# **Service Bulletin**

GM Bulletin No.: 13272

**SUBJECT:** Service Update for Inventory Vehicles Only

MODELS: 2014 Chevrolet Cruze

3613309

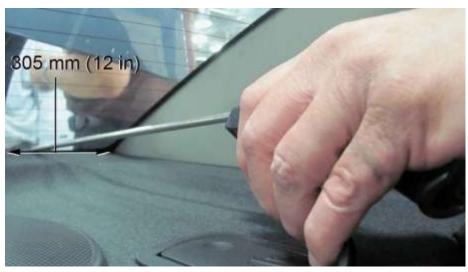
**Note:** Some vehicles may have a urethane sealing issue in the area shown in the photograph. The area of concern is a 305 mm (12 in) section of the rear window glass that begins at the left (driver side) lower corner and ends near the CHMSL. The urethane sealing issue, if present, may allow water to enter the trunk. Look for evidence of a water leak in the trunk.

1. Locate the rear left (driver side) window glass (1) and rear window water deflector (2).

2. Apply a soap and water solution under the water deflector in the 305 mm (12 in) section of the rear glass shown in the photograph.

**Note:** Have a second technician sit in the rear seat of the vehicle to apply air pressure to the rear glass during and after step 2. Use a small air nozzle to apply compressed air to the inspection area. Refer to photograph.

- 3. Apply compressed air to the bottom edge of the rear glass in the inspection area indicated in the photograph.
- 4. Determine if a water leak is present. Examine the soap and water solution to determine if a water leak is present.
  - If a water leak is NOT present, no further action is required.
  - If a water leak is present, remove and replace the rear window glass. Refer to *Rear Window Replacement* in SI.
